Submittal Detail

SB 1022 Classroom and Vocational Training Center Project

SUB-13 34 19-2-009		Rev: 0	Stage:	Closed
Assigned To				
Bid Package	Trade Contact	Trade Company	Due to CM	
BP-02A-Gilbane Kitchell CPM	Starr, Cameron		09-01-2017	
Register Item Information				
Description				
Mezzanine Shop Drawings rev				
CSI Code	Sub Section	Туре	Category	
133419		Shop Drawing	For Approval	
Notes

SUPPORT PLATFORM

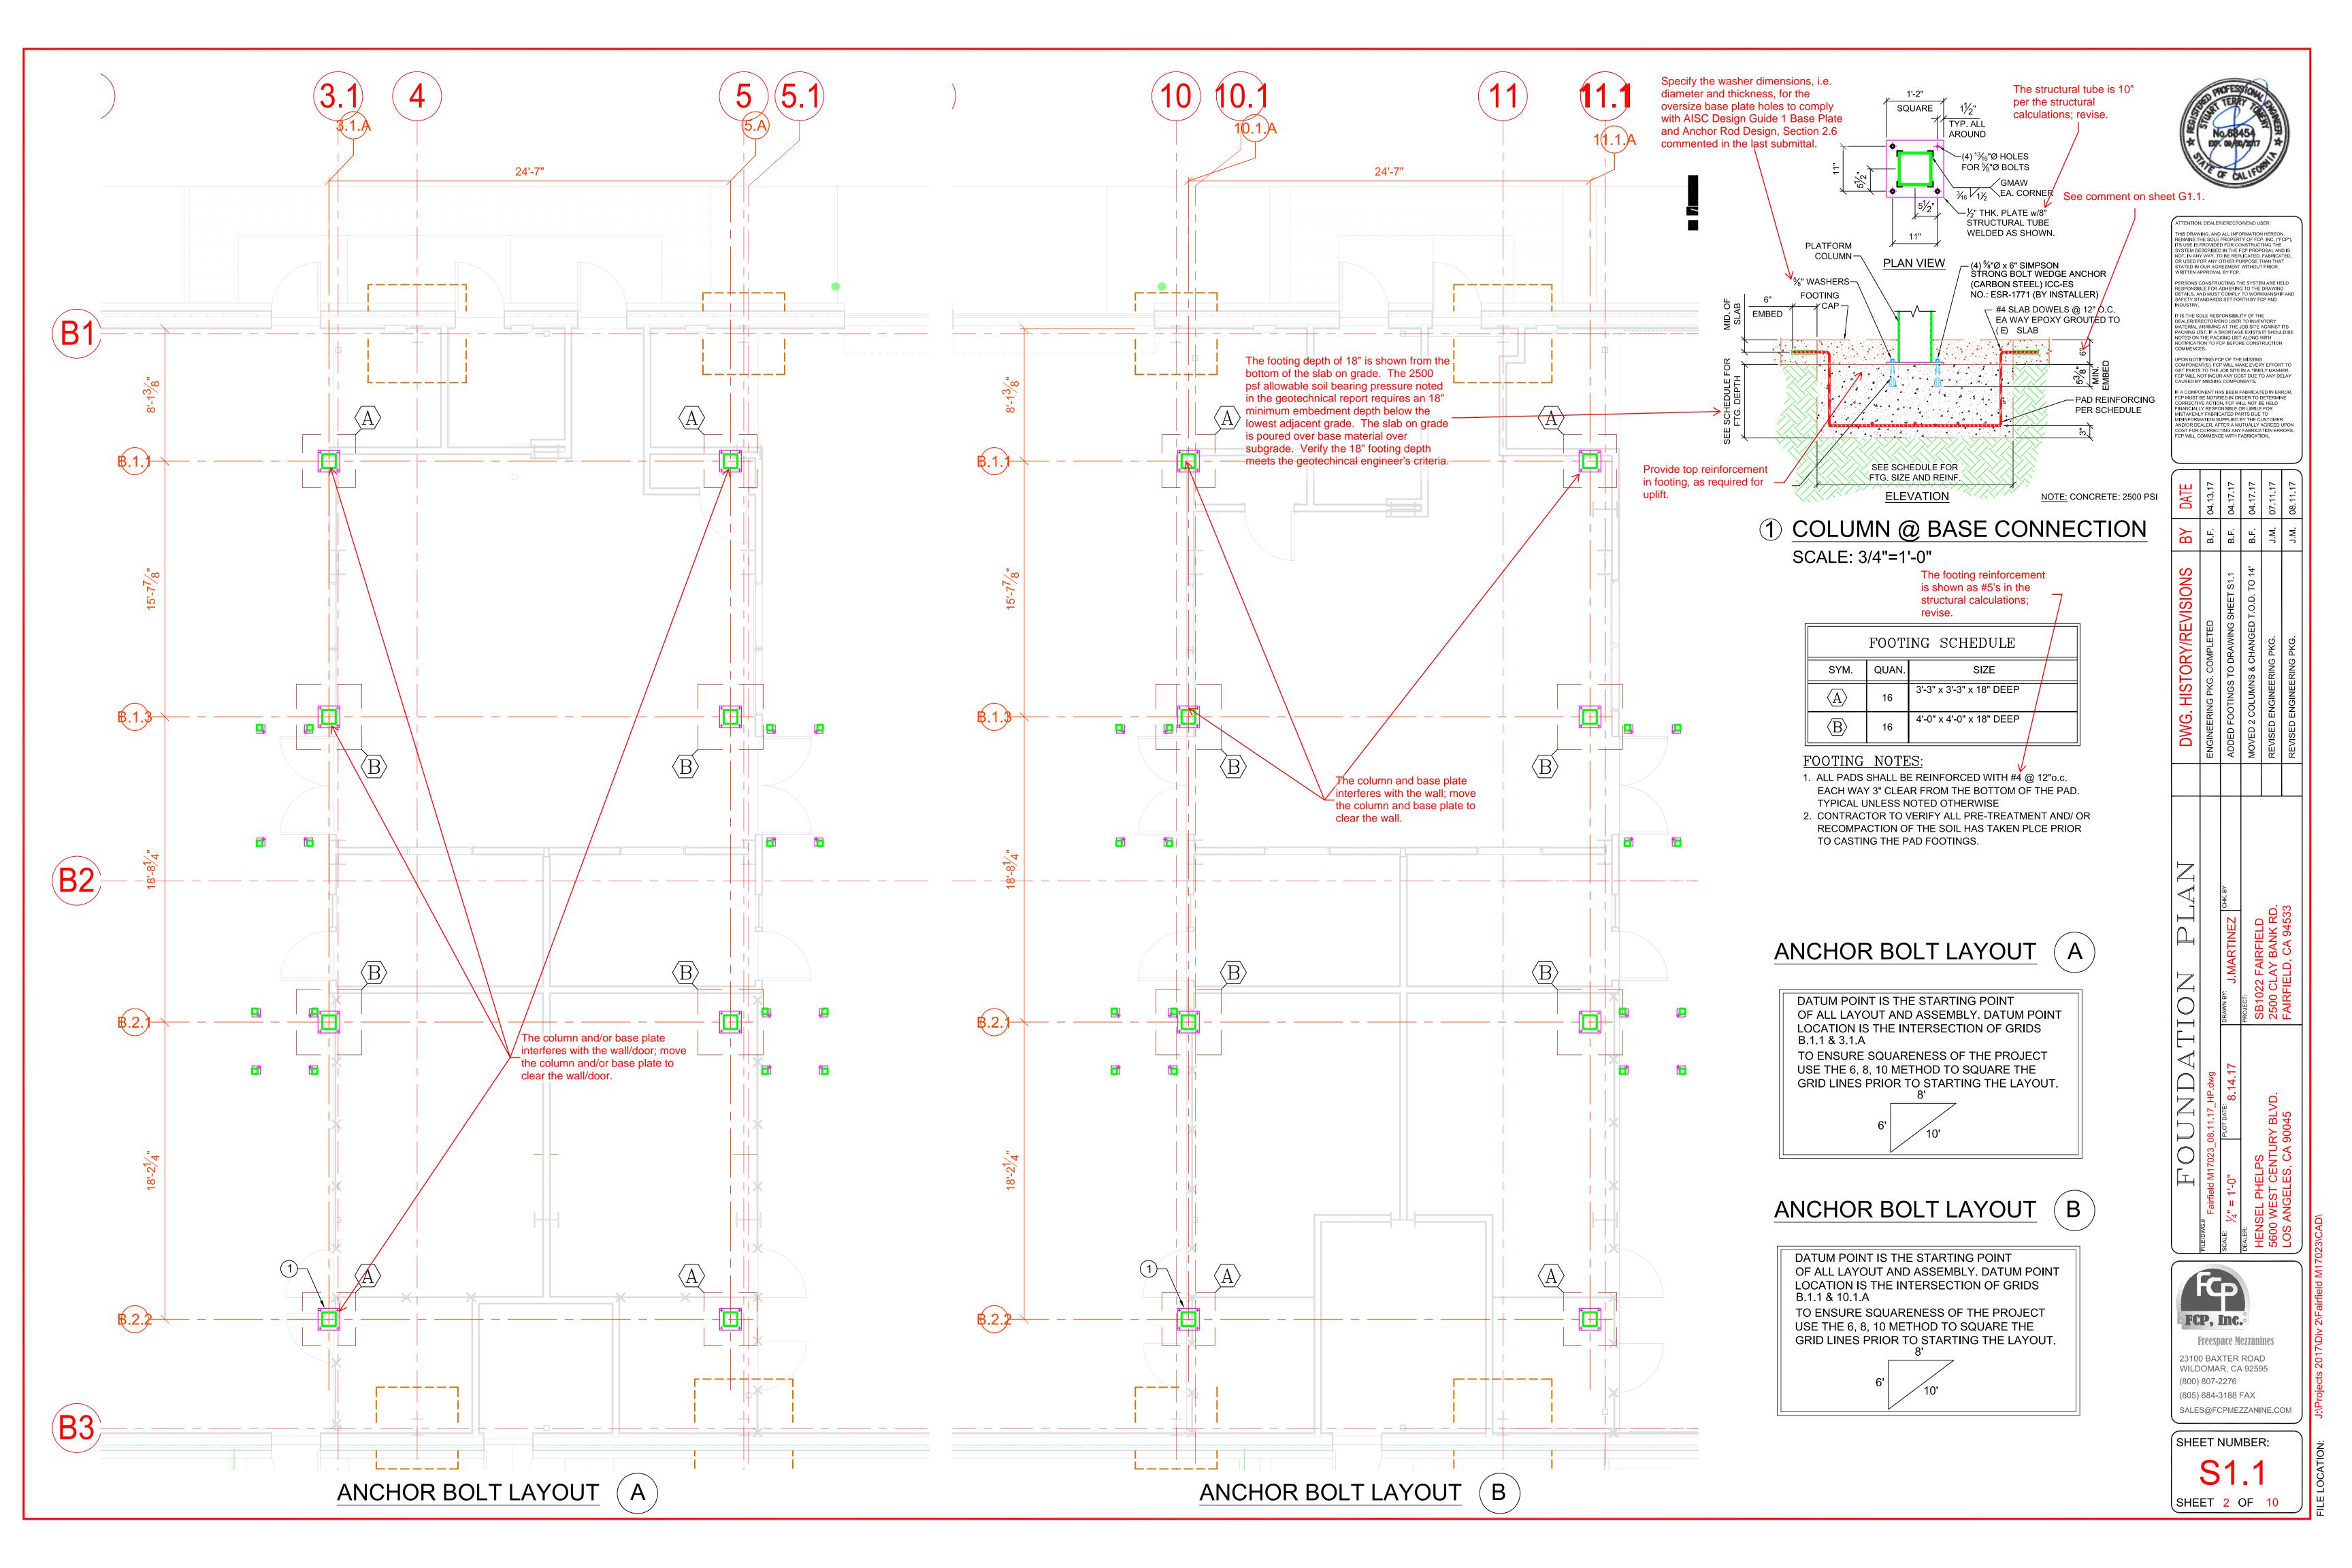
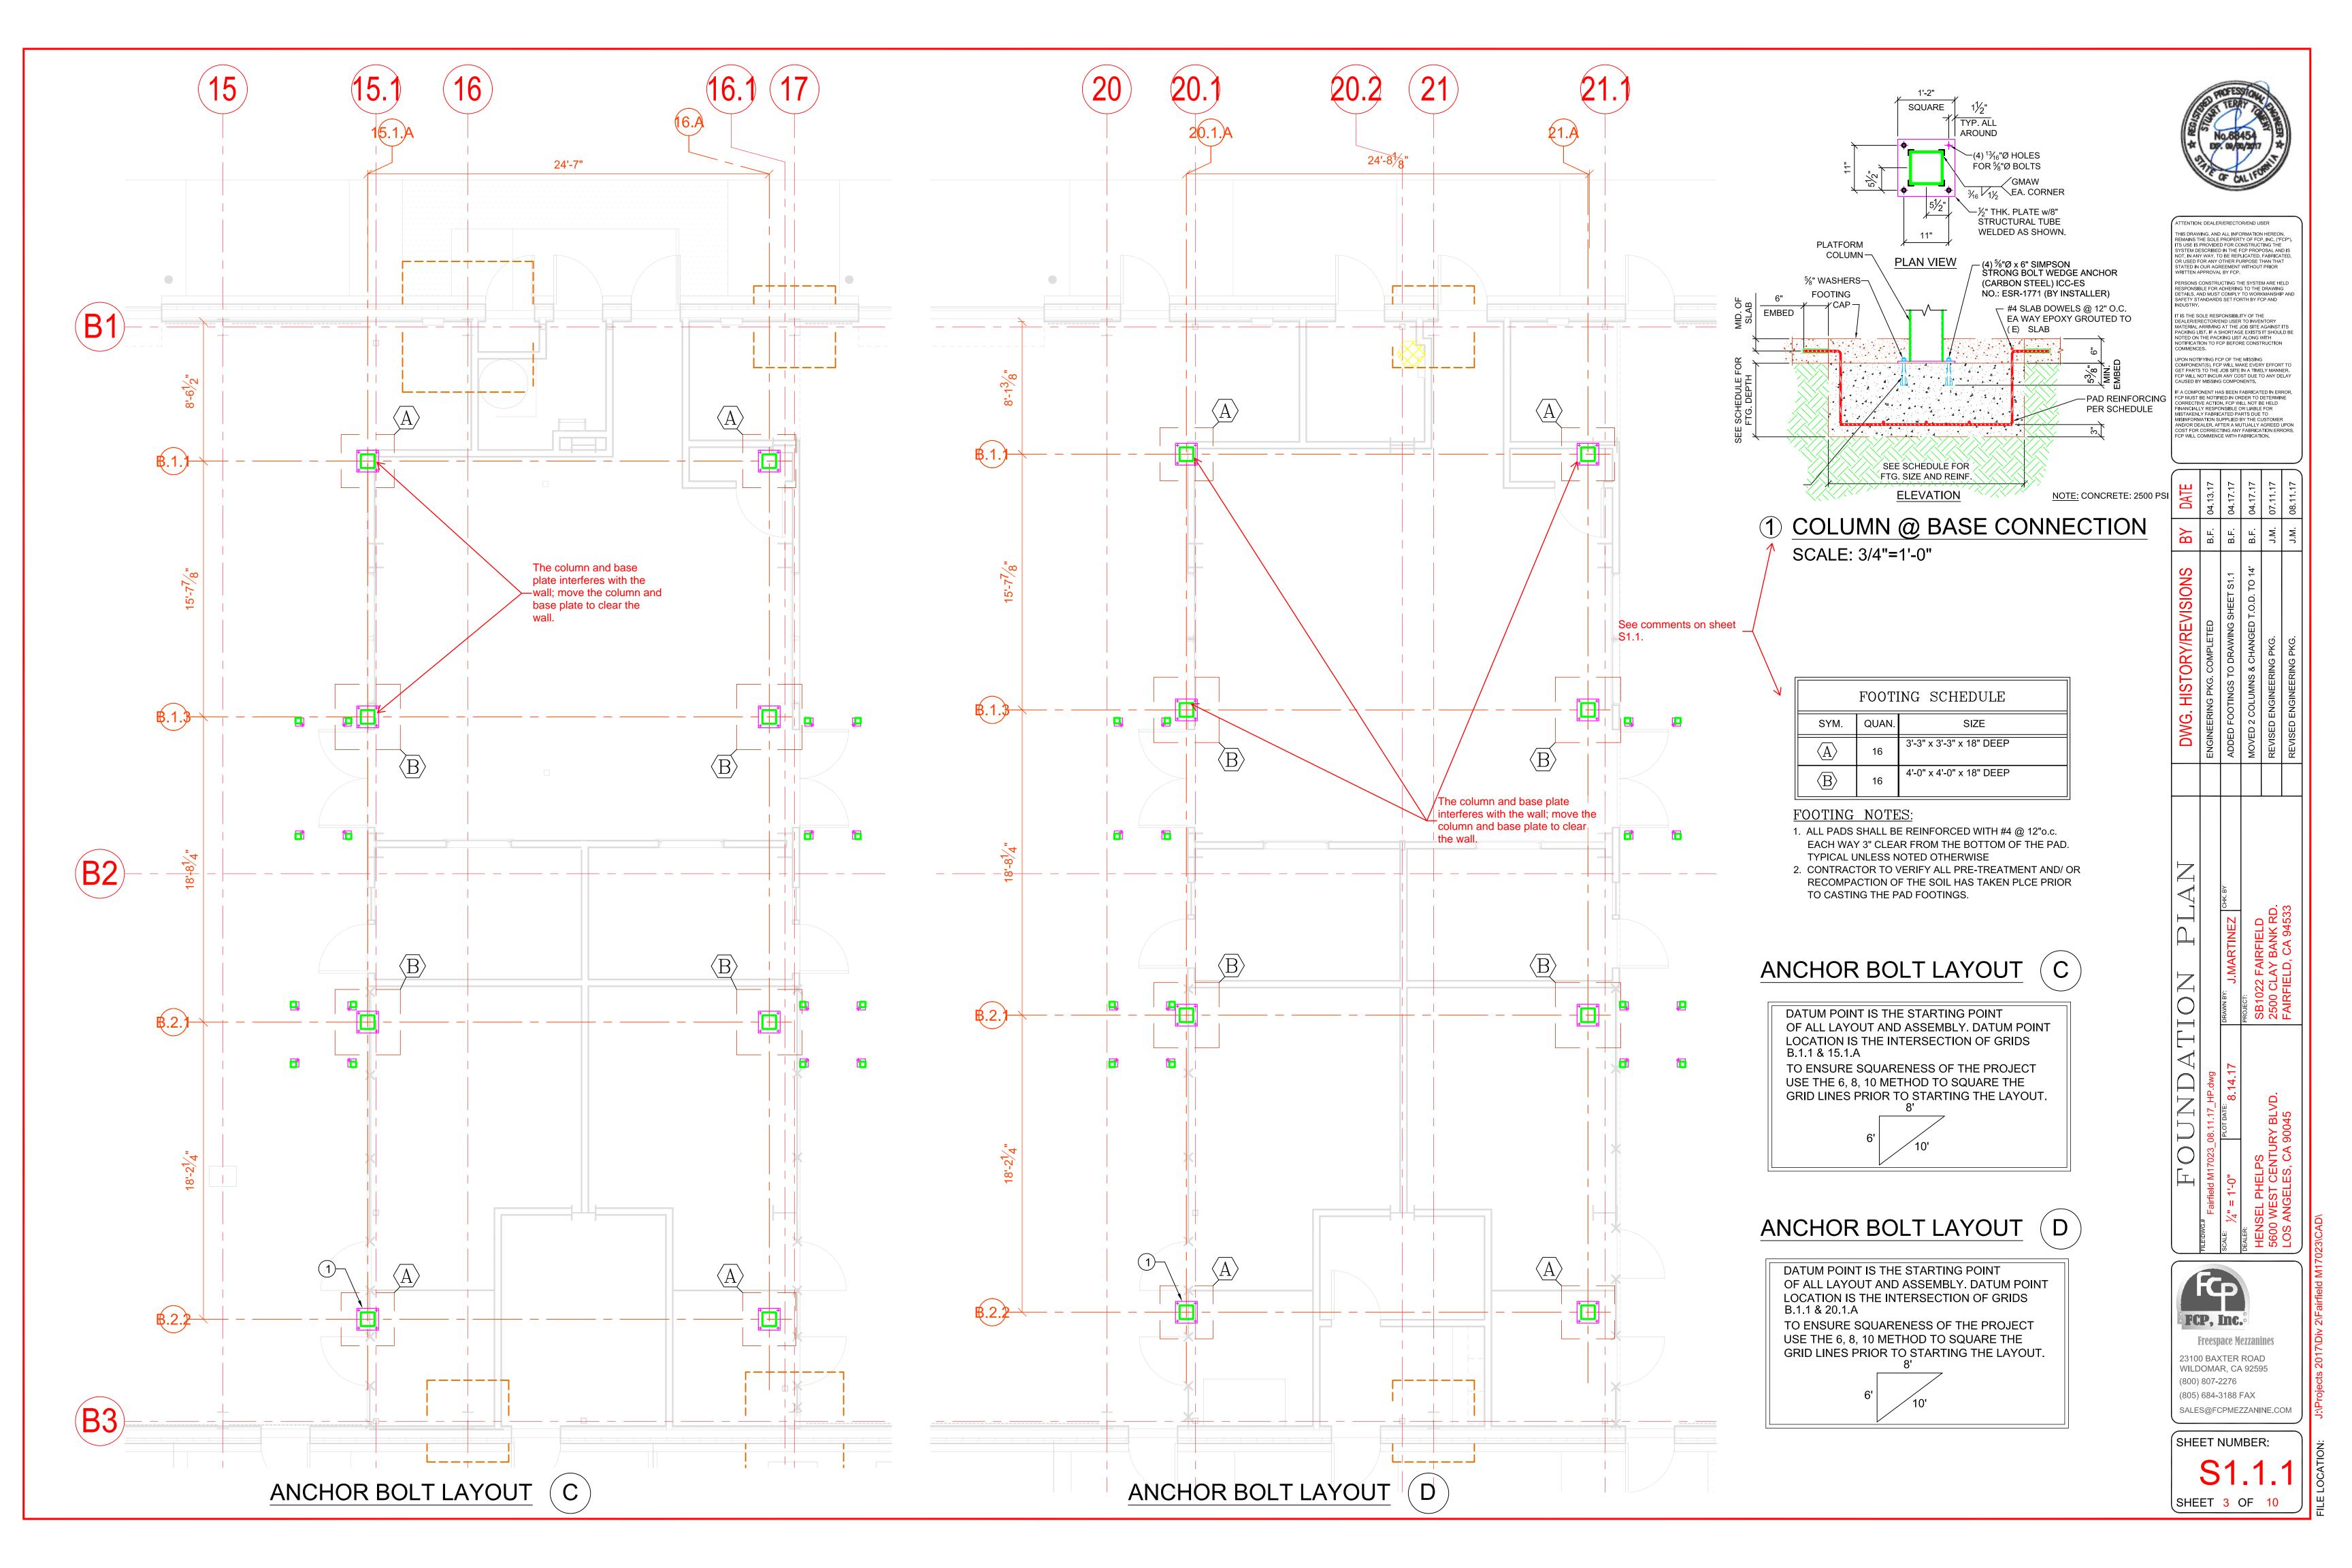
Coordinate all mechanical openings and mechanical equipment structural support with new designed structural system including but not limited to penings indicated on shop drawings.

> 2013 per structural calculations; revise

Factor is 1.25 per LIGHT STORAGE the structural **SPECIFIC USE:** calculations: revise

The design soil pressure is 2500 psf

2. 6" SLAB per the structural calculations; revise.

The slab is 5" at the mezzanine or 3. 2500 PSI CONCRETE -6" outside of the mezzanine area

- see sheets S202 and S203. 4. BUILDING TYPE:

ALL STRUCTURAL STEEL SECTIONS AND WELDED PLATE MEMBERS SHALL CONFORM TO ASTM A36 UNLESS NOTED AS GR.50 ON THE PLANS, IN WHICH CASE THEY SHALL CONFORM TO ASTM A572, STRUCTURAL STEEL TUBING SHALL CONFORM TO ASTM A-500 GRADE "C". STEEL PIPE COLUMNS SHALL BE GRADE "B" CONFORMING TO ASTM A53. ALL PRIMARY AND SECONDARY FRAMING MEMBERS ARE FABRICATED FROM ASTM A653 GRADE 55 (Fy-55 KSI. MIN.) AND ARE G60 Verify ASTM A-500 grade "C" is available for the steel

tubes. AISC Table 2-3 noted that this grade should be checked for availability prior to specifying its use.
